June 6, 2026

Addendum No.3

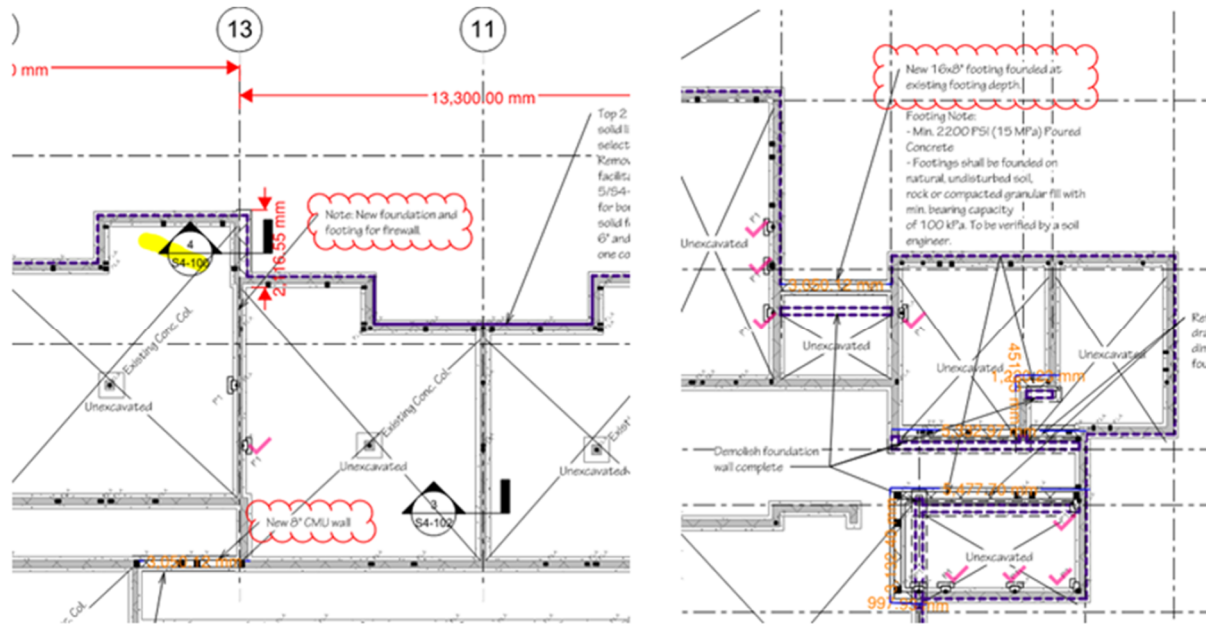
Please provide the rebar details of the following indicated on the Drawing S4-100:

- A) new 8" CMU wall. Please see the attached Photo (clouded) for reference.
- B) new 16x8 footing foundation. Please see the attached Photo (clouded) for reference.

Answer: Refer to the updated structural drawings Sheet S4-100 and S4-103, details 5 and 6.
